MEMORANDUM

TO: Heritage Markham Committee

SUBJECT: Site Plan Application
4340 Highway 7 East, Unionville
Façade Modifications

FILE: SPC 22 244216

SOUTH & WEST ELEVATIONS

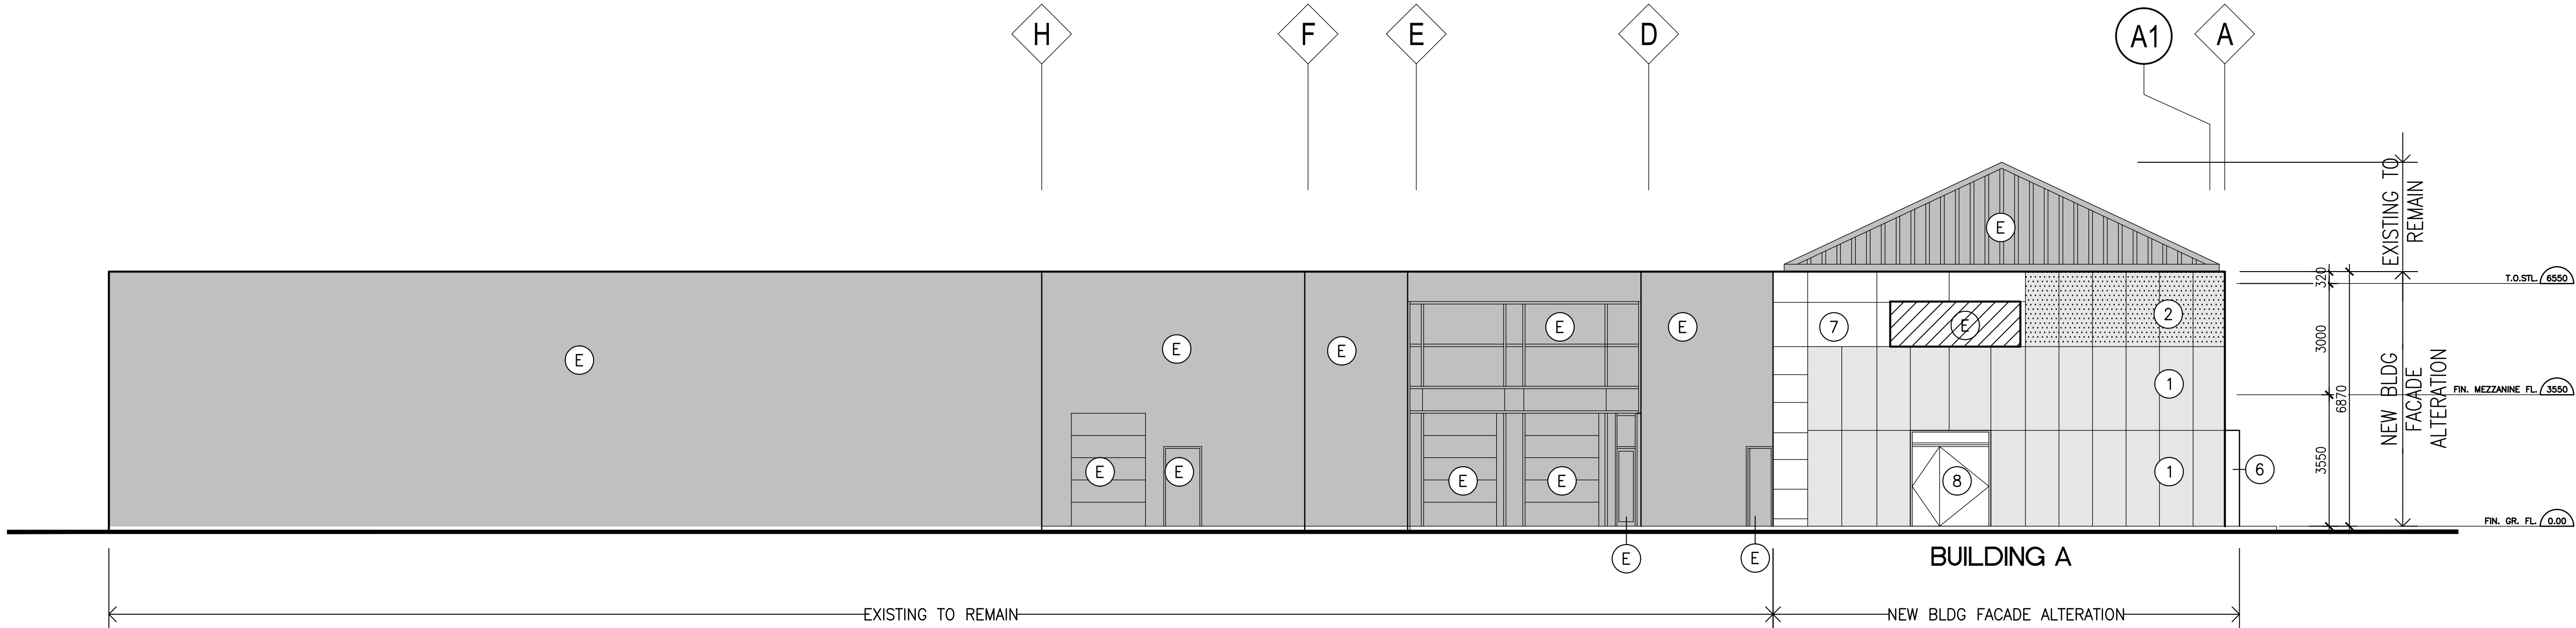
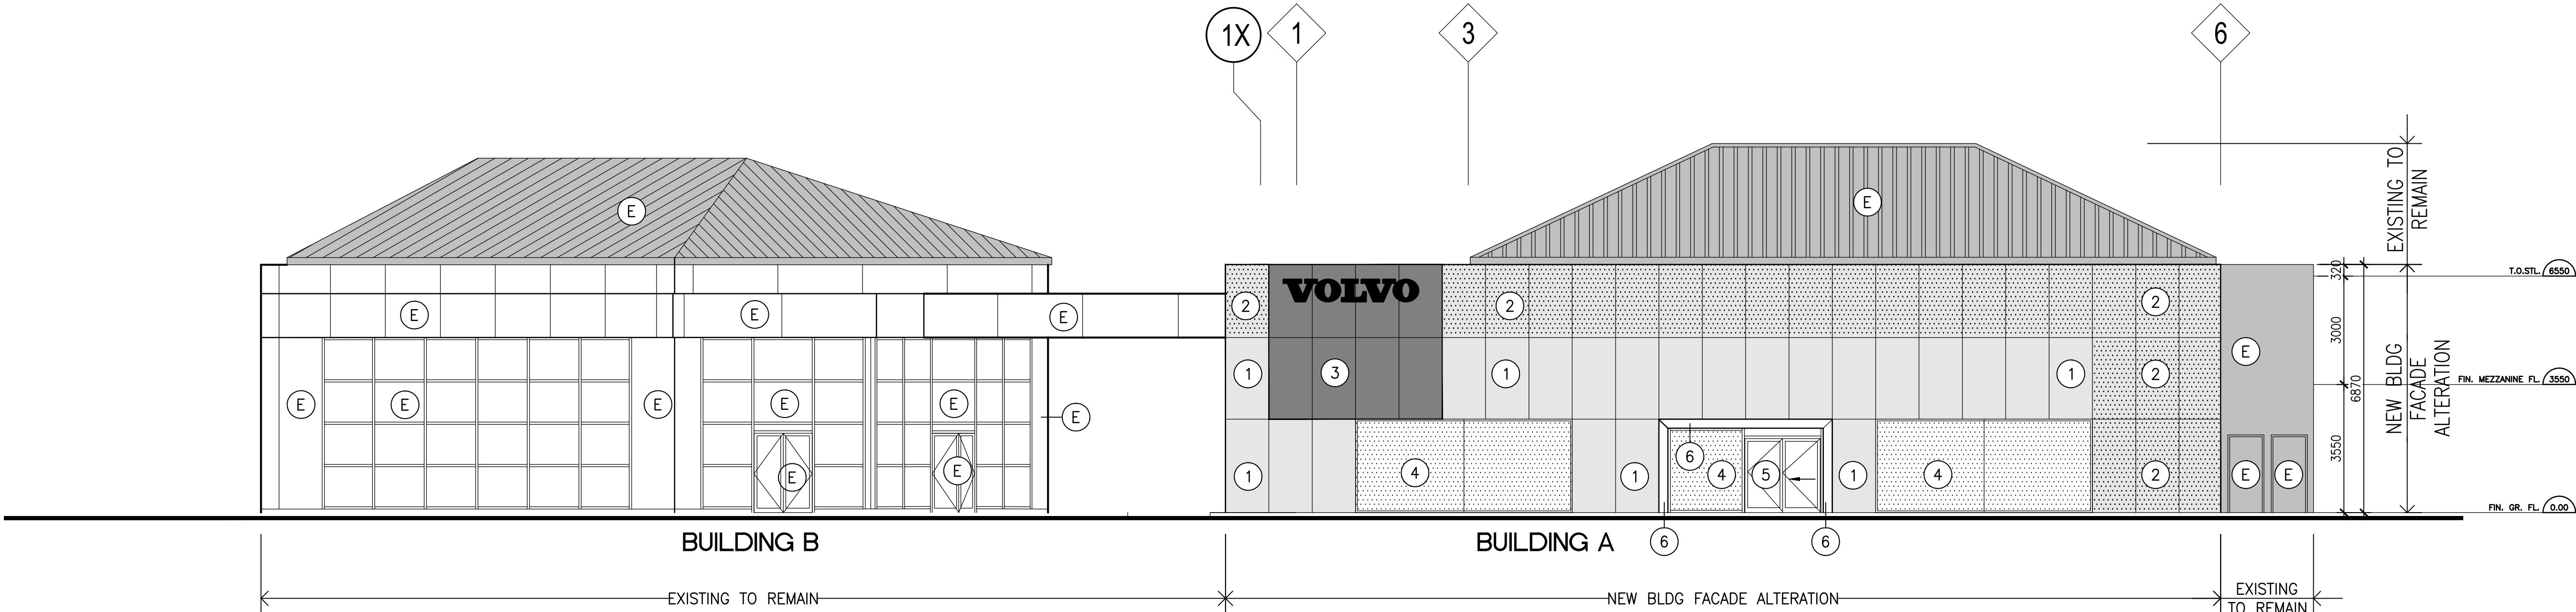
- Specifically, the south elevation of Bldg A will be squared off by removing 17.22 square metres of floor area and adding 23.69 square metres of new floor area. The net difference will be an additional 6.47 square metres of floor area. As per the applicant, the proposed modifications are being undertaken to suit corporate branding requirements from Volvo, the current tenant. As the increase in the building footprint is under 50 square metres, the SPC application is considered minor in nature;

- Proposed materials are generally in keeping with the existing palette, consisting of a mixture of glazing types and metal/composite panels. New signage is also proposed.

- Heritage Section staff (“Staff”) have no objection to the proposed building modifications as they are in keeping with the architectural character of the existing complex, and as such are generally in keeping with direction in the UHCD Plan;
- At the request of Staff, a landscaped buffer is being introduced along the southern frontage of the subject property. This will reintroduce planting material in a location that softens the appearance of the complex as seen when entering the UHCD from Highway 7 East. Information on the location and type of proposed plantings is included as ‘Appendix D’ of this memo;
- New exterior signage is proposed, and will be detailed in a forthcoming signage permit application. Staff will evaluate the proposed signage to ensure it adheres to direction in the Signage By-law (2002-94) for heritage properties.
